PROJECT NO. 278-91 (391-199)

PROJECT Water Control Structure at  
Salt Bayou

Review of Aviles Report  
on Salt Bayou Water Control Structure

## SUMMARY OF LABORATORY TEST DATA

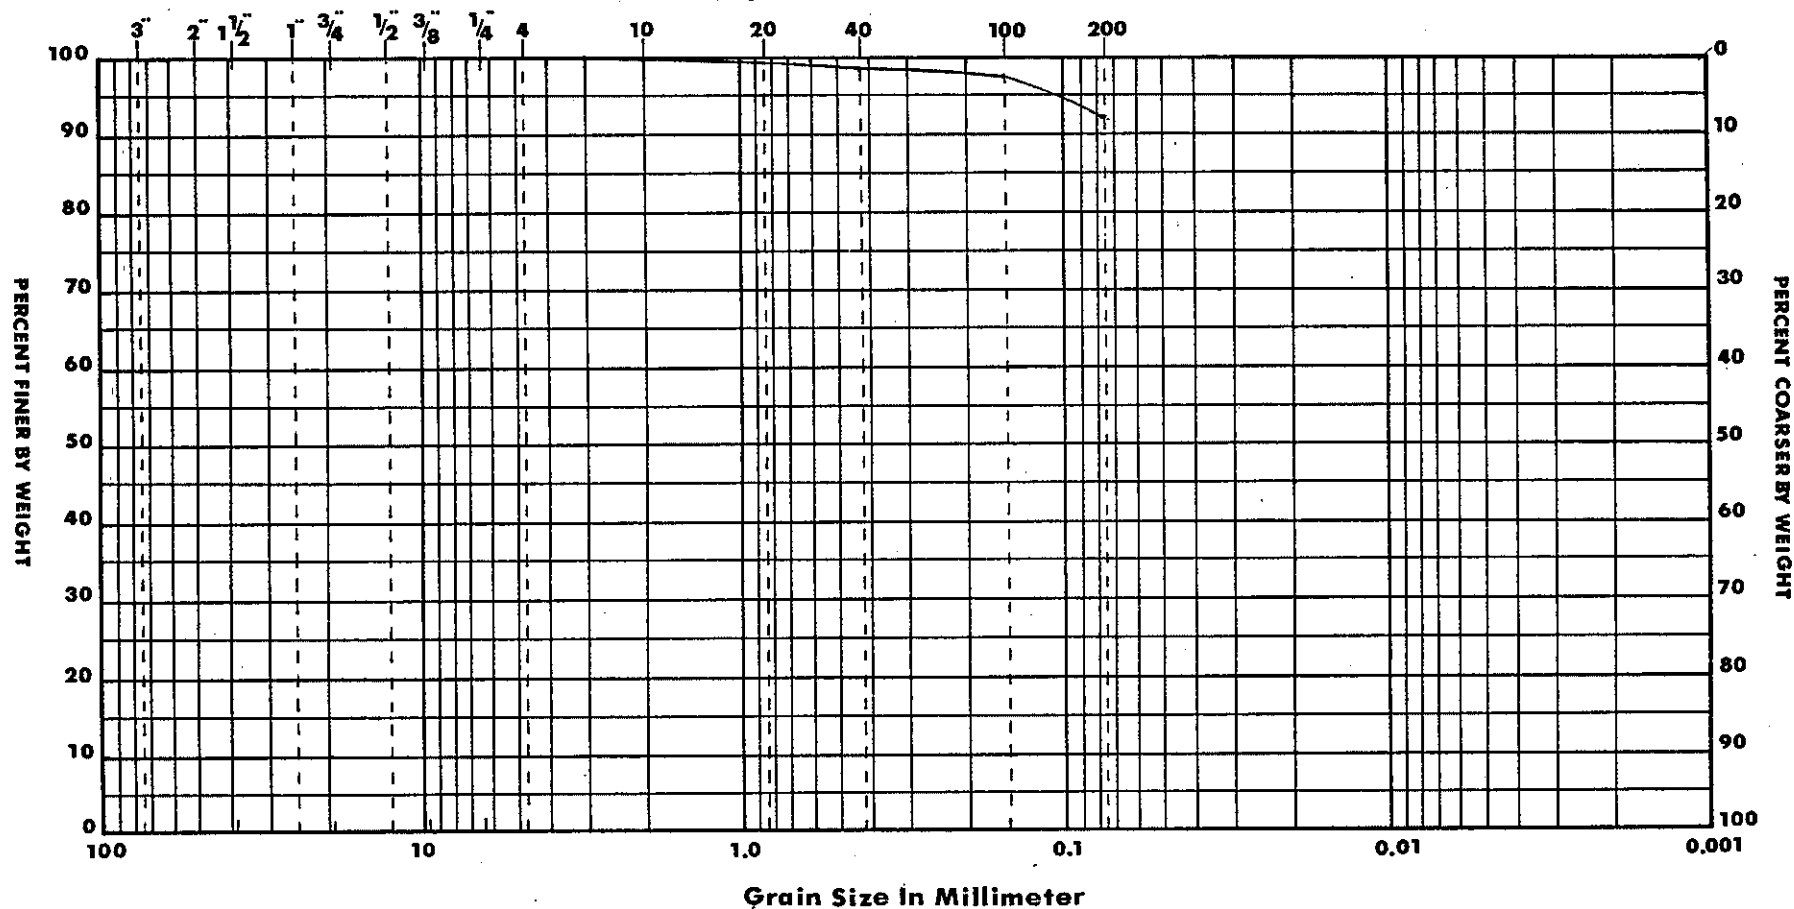
3. A number of the torvane readings shown on the plots indicate no shear strength. What in fact were the torvane readings? A tabulation of the torvane readings should have been presented on the Summary of Laboratory Test Data.
